A D D E N D U M #2

Project	Nelson H.S. Renovations	**Project No.**	2323
Location	4181 New Street, Burlington, Ontario	**Date of Issue**	2024 05 30
Owner	The Halton District School Board	**File**	2323/7.1.3

This Addendum forms part of the Contract Documents and amends the original Drawings and Specifications, dated 2024 05 13, as noted below.

1 / A207 1963 CLASSROOM WING - FIRST FLOOR PARTIAL RENOVATION PLAN
1:100

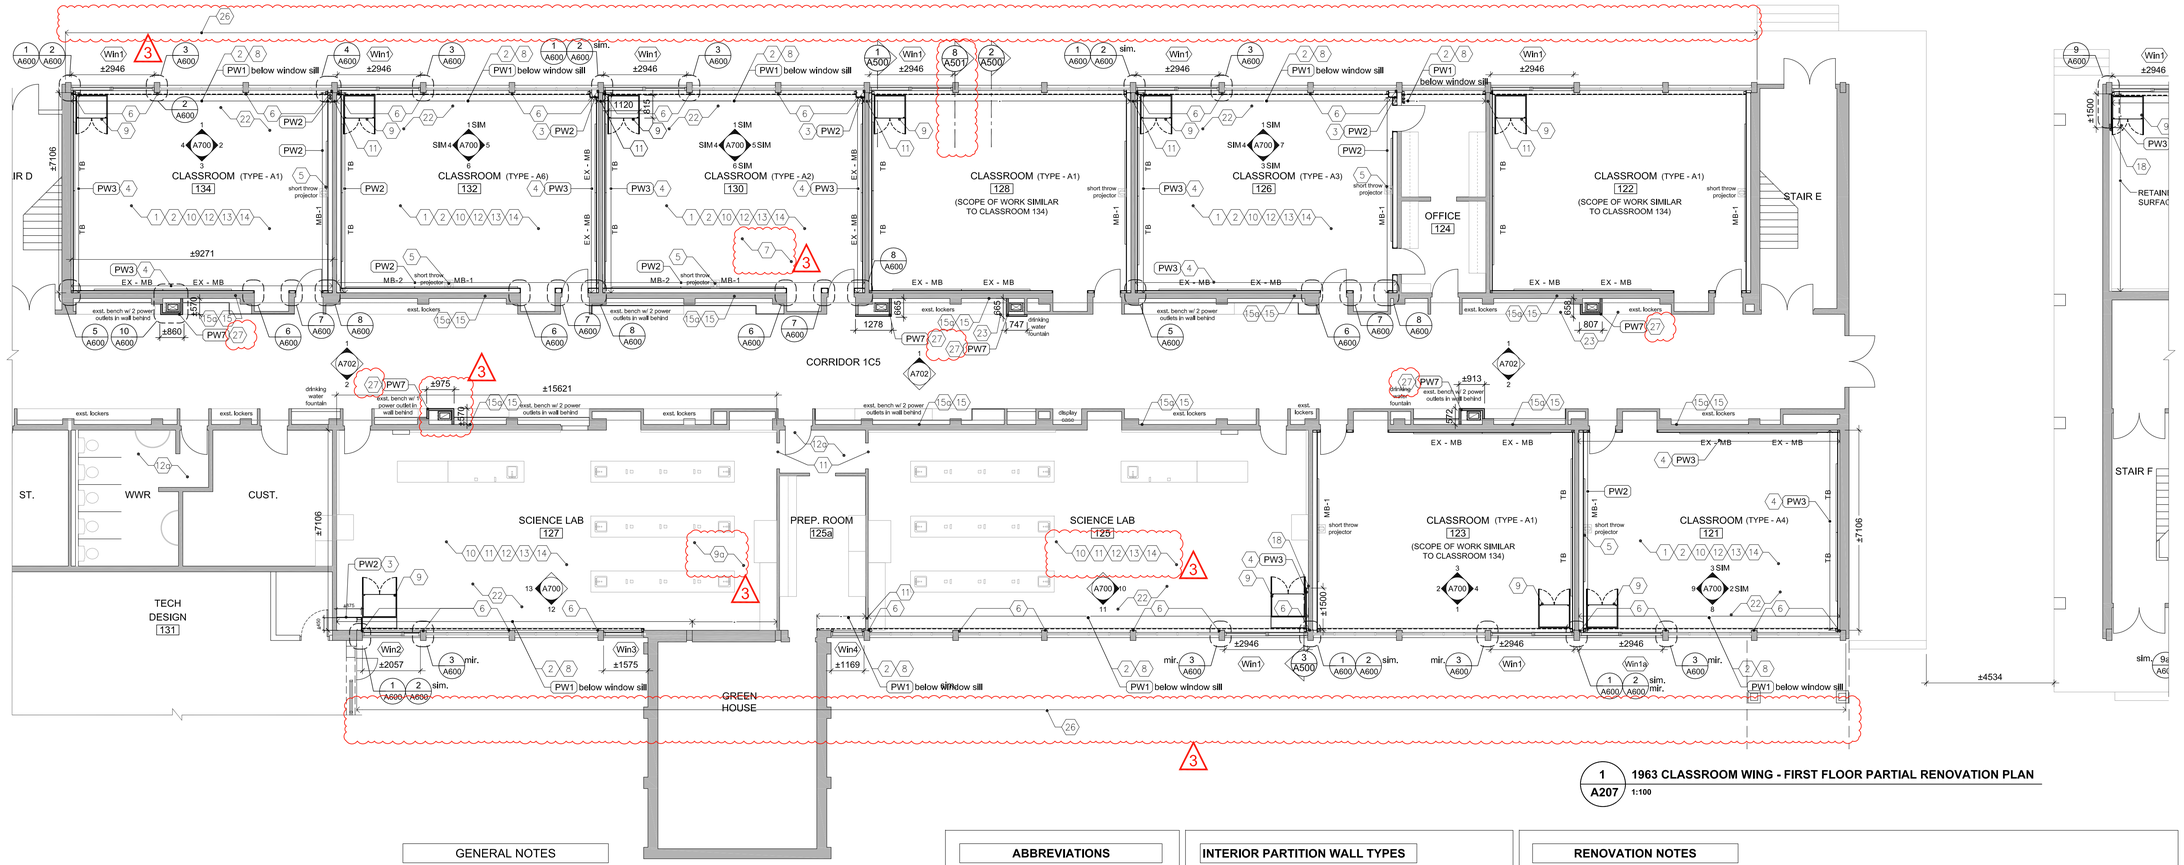
.2 Replace Renovation note no. 3 and 18

.3 Add Renovation note no. 9a, 24, 25, 26, 27 and 28

.4 Add Fire Rating Notes and Fire Proofing Notes

.5 Add note no. 26 and 27 locations on drawing

.6 Add note no. 9a in Rm 127

.7 Revise Renovation note numbers in Rm 125

.8 Add wall section tag reference for typical existing column cladding section detail

1 / A208 1956 CLASSROOM WING - FIRST FLOOR PARTIAL RENOVATION PLAN
1:100

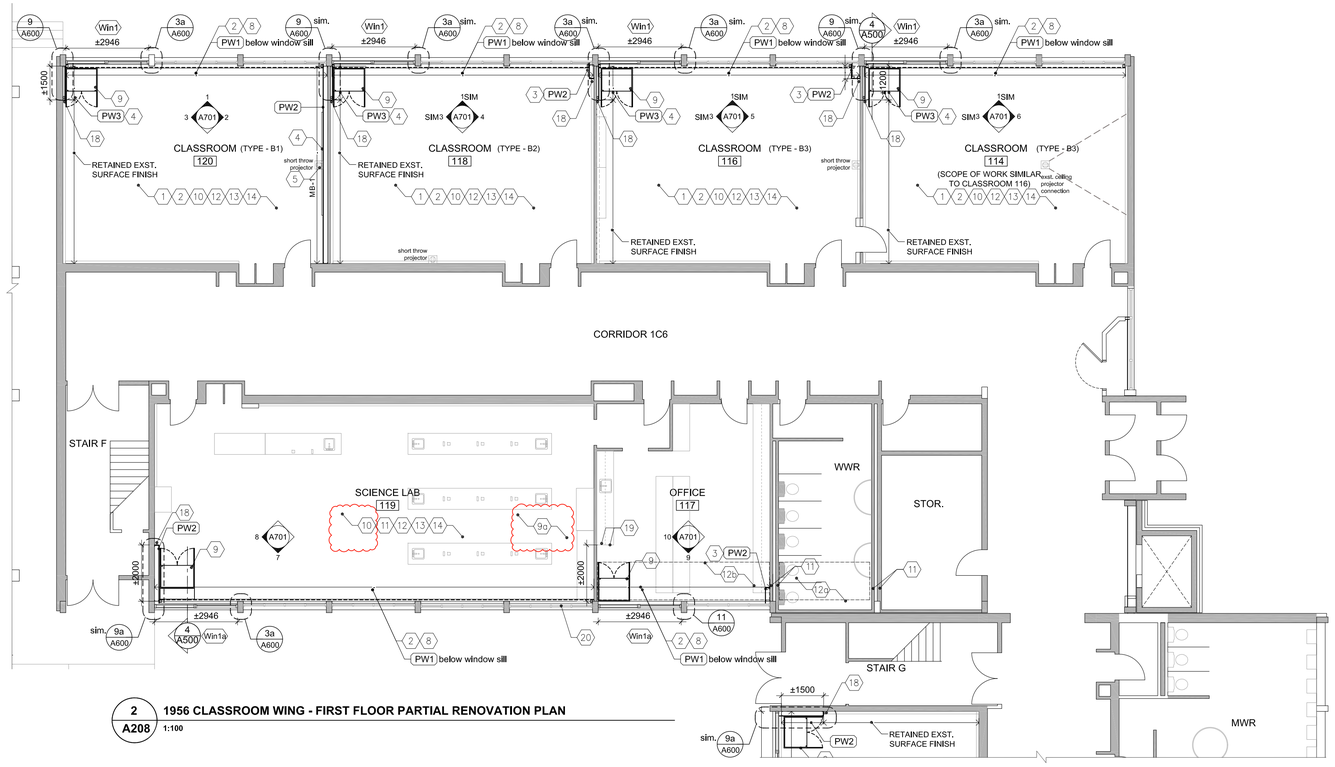
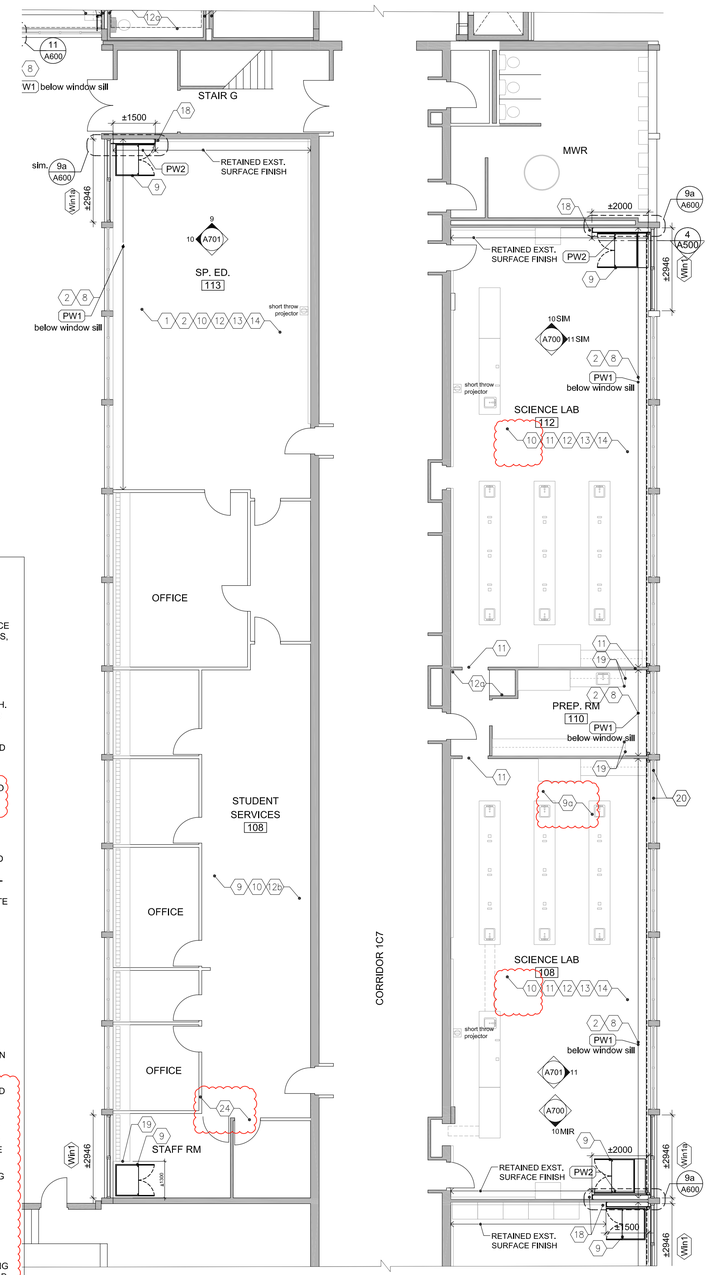
.2 Replace Renovation note no. 3 and 18

.3 Add Renovation note no. 9a, 24, 25, 26, 27 and 28

.4 Add Fire Rating Notes and Fire Proofing Notes

.5 Add note no. 9a in Rm 108 and 119

.6 Add note no. 24 location on drawing

.7 Add Renovation note no. 10 in Rm 108, 112, 119

1 / A209 **1956 WING - FIRST FLOOR PARTIAL RENOVATION PLAN (BOILER RM, CLASSROOMS, FAMILY STUDIES AND HOME ECO.)** 1:100

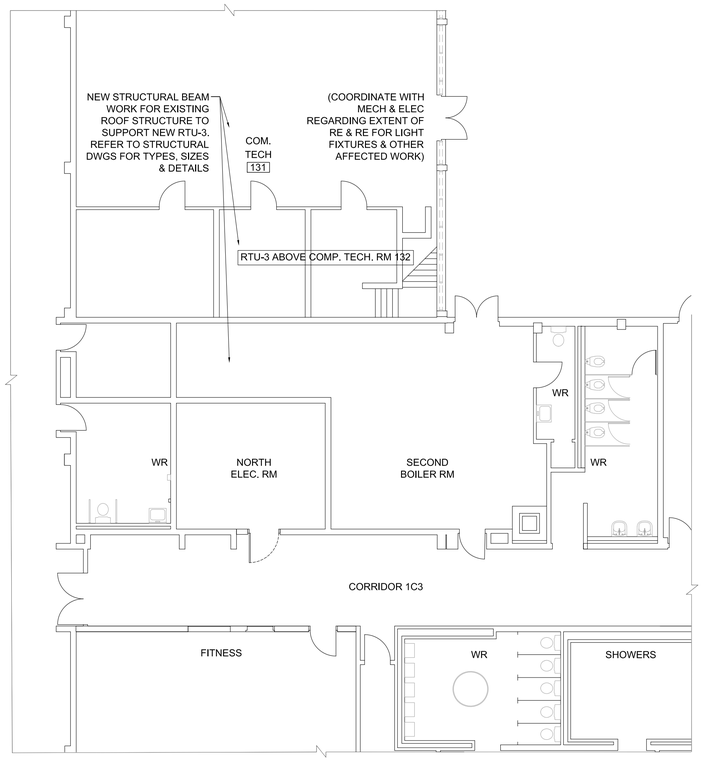
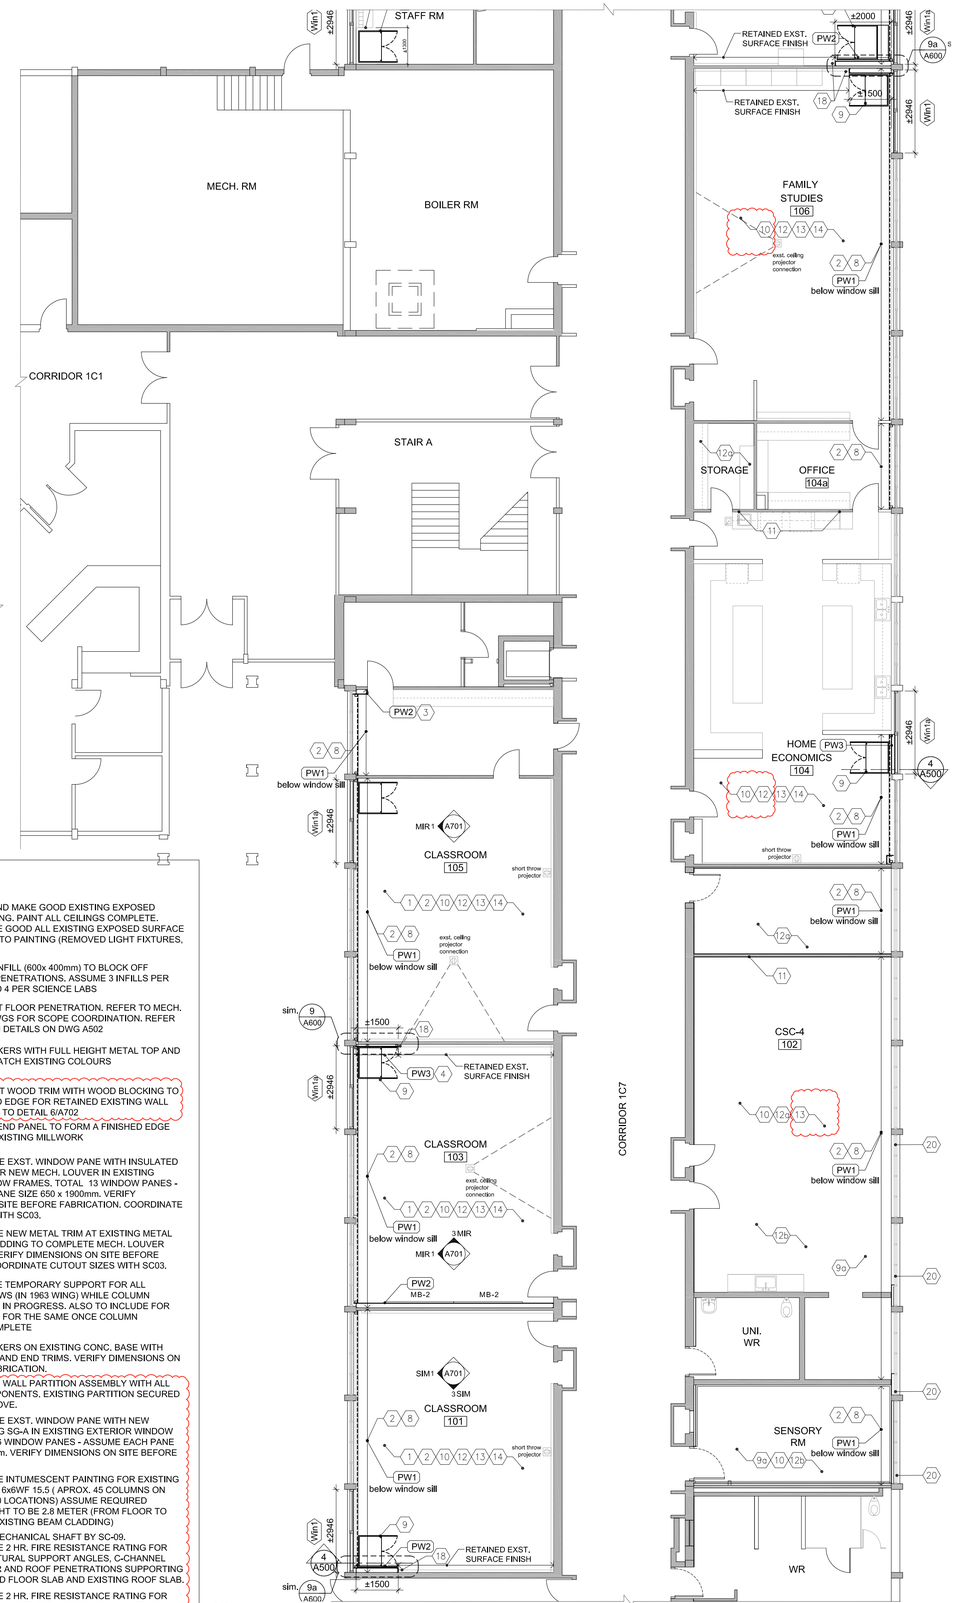
.2 Replace Renovation note no. 3 and 18

.3 Add Renovation note no. 9a, 24, 25, 26, 27 and 28

.4 Add Fire Rating Notes and Fire Proofing Notes

.5 Add Renovation note no. 10 in Rm 106, 104

1 / A210 1963 CLASSROOM WING - SECOND FLOOR PARTIAL RENOVATION PLAN
1:100

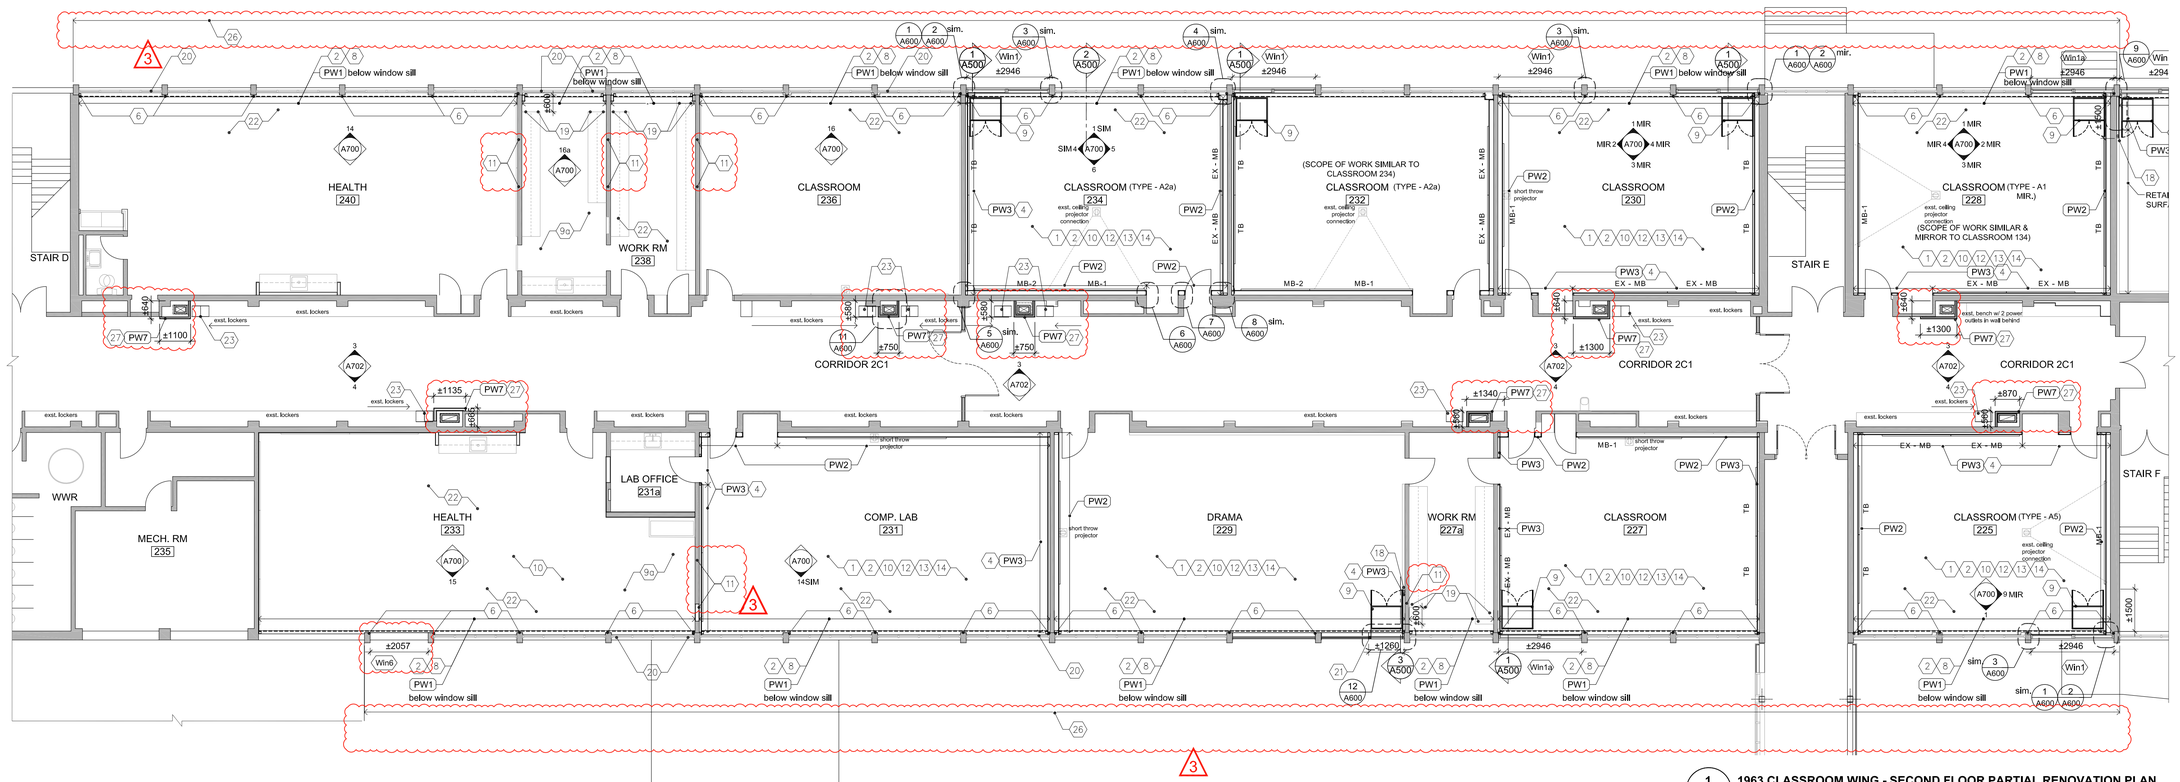
.2 Replace Renovation note no. 3 and 18

.3 Add Renovation note no. 9a, 24, 25, 26, 27 and 28

.4 Add Fire Rating Notes and Fire Proofing Notes

.5 Add note no. 26 and 27 locations on drawing

.6 Add note no. 11 in Rm.227a, 231, 233, 236, 238, 240

1 / A211 1959 CLASSROOM WING - SECOND FLOOR PARTIAL RENOVATION PLAN
1:100

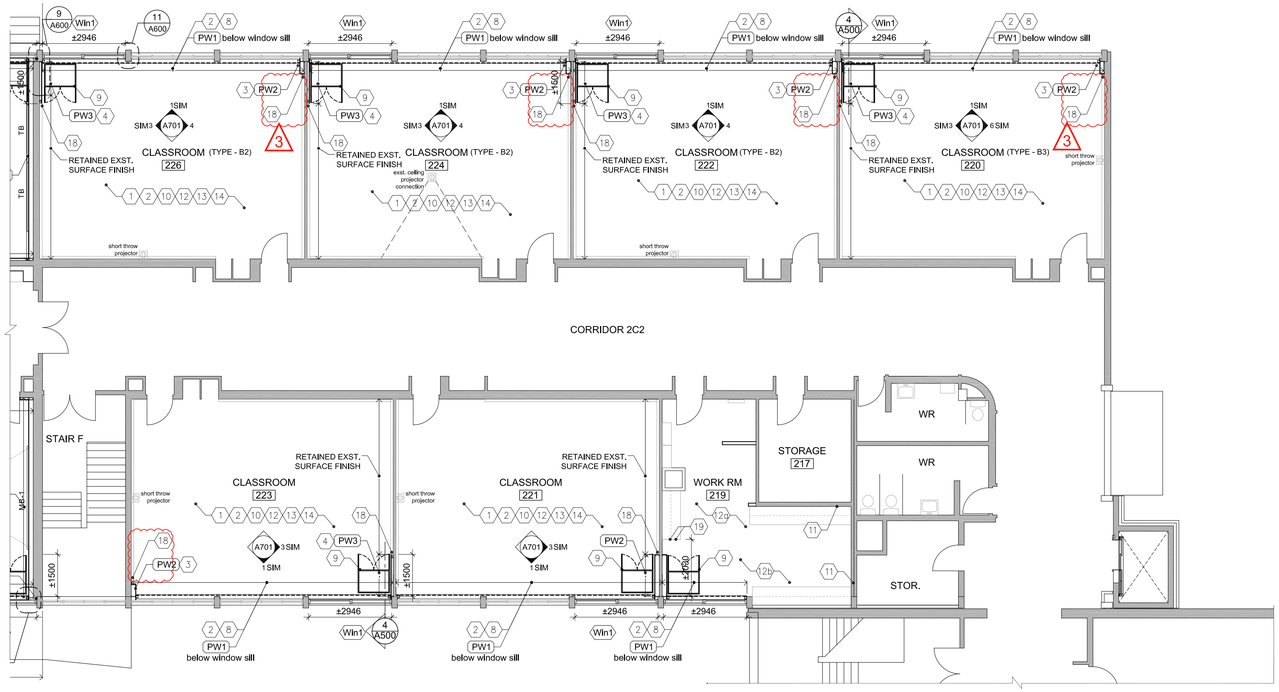
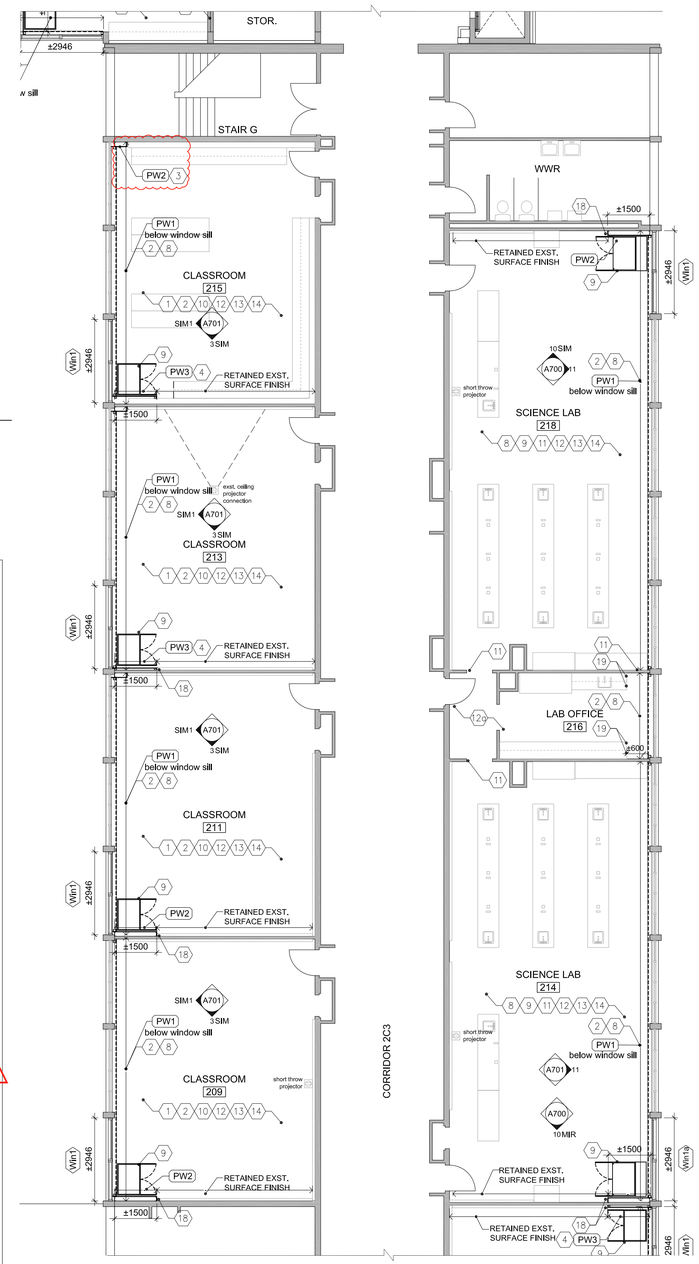
.2 Replace Renovation note no. 3 and 18

.3 Add Renovation note no. 9a, 24, 25, 26, 27 and 28

.4 Add Fire Rating Notes and Fire Proofing Notes

.5 Add note no. 18 in Rm. 220, 222, 223, 224, 226

.6 Add note no. 3 in Rm. 215

1 / A300 **1963 CLASSROOM WING - FIRST FLOOR PARTIAL RCP**
1:100

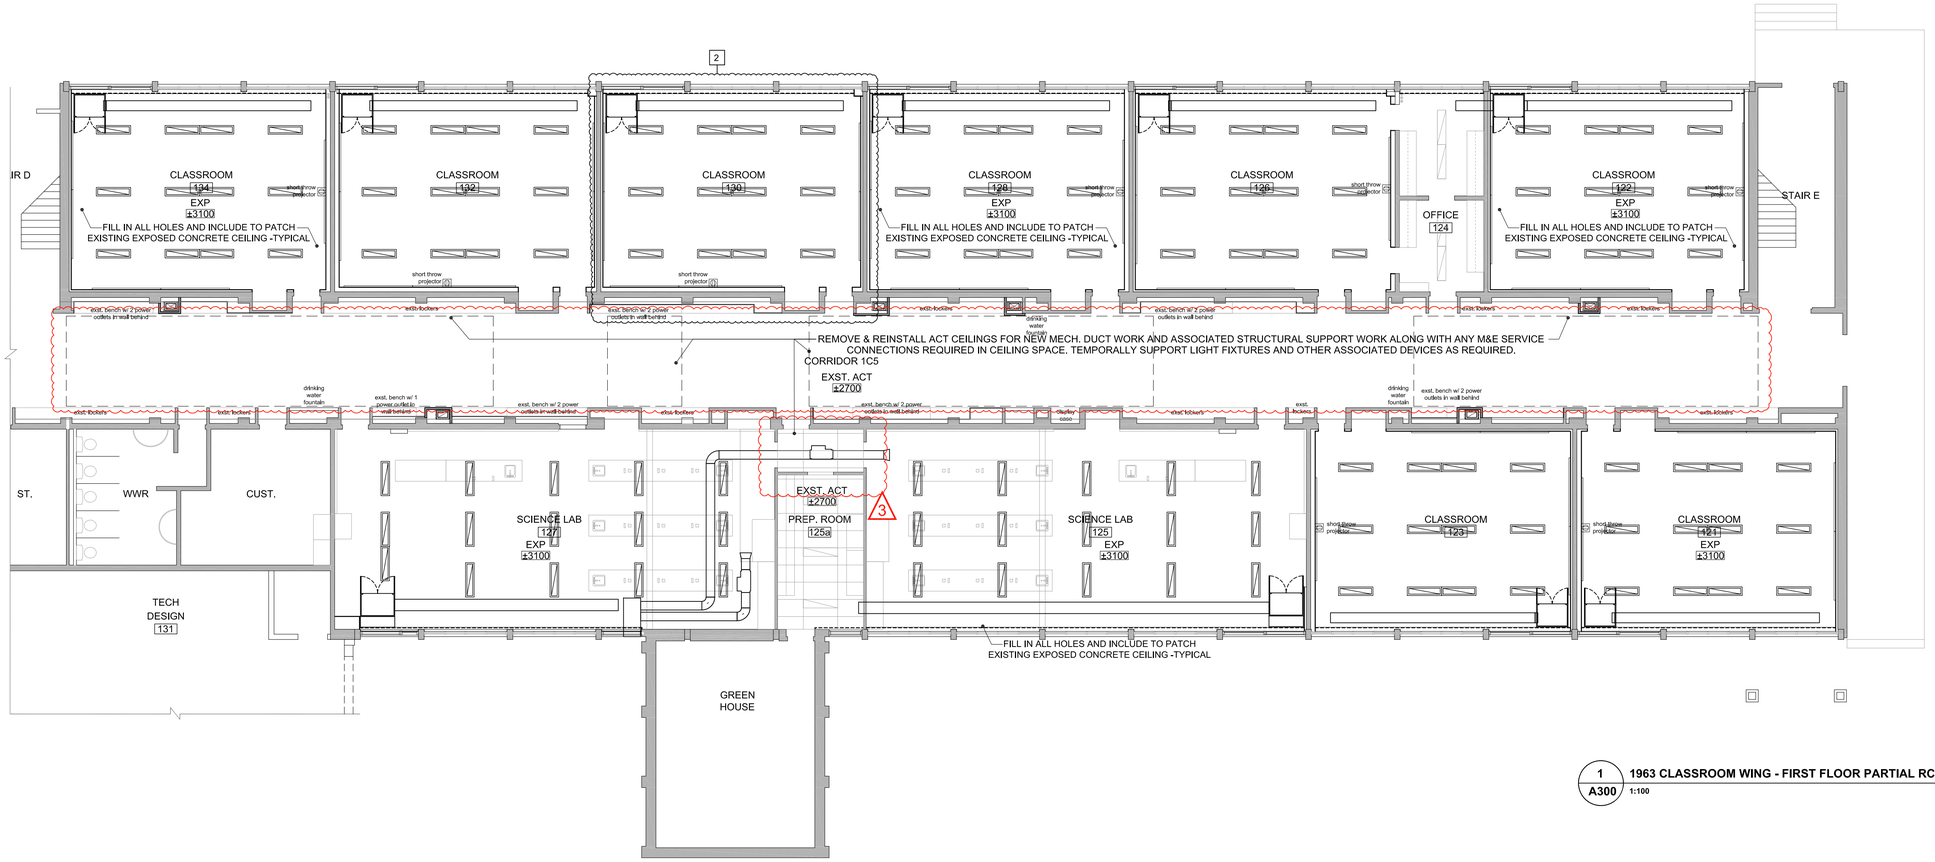
.2 Add 'Re & Re' Corridor Ceiling notes to complete required M&E service connections

13 / A501 TYP. DUCT PENETRATION SECTION DETAIL @ CORRIDOR ROOF 1:5

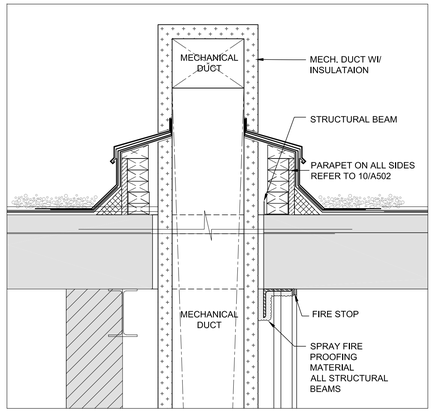
.3 Revise detail no. 13
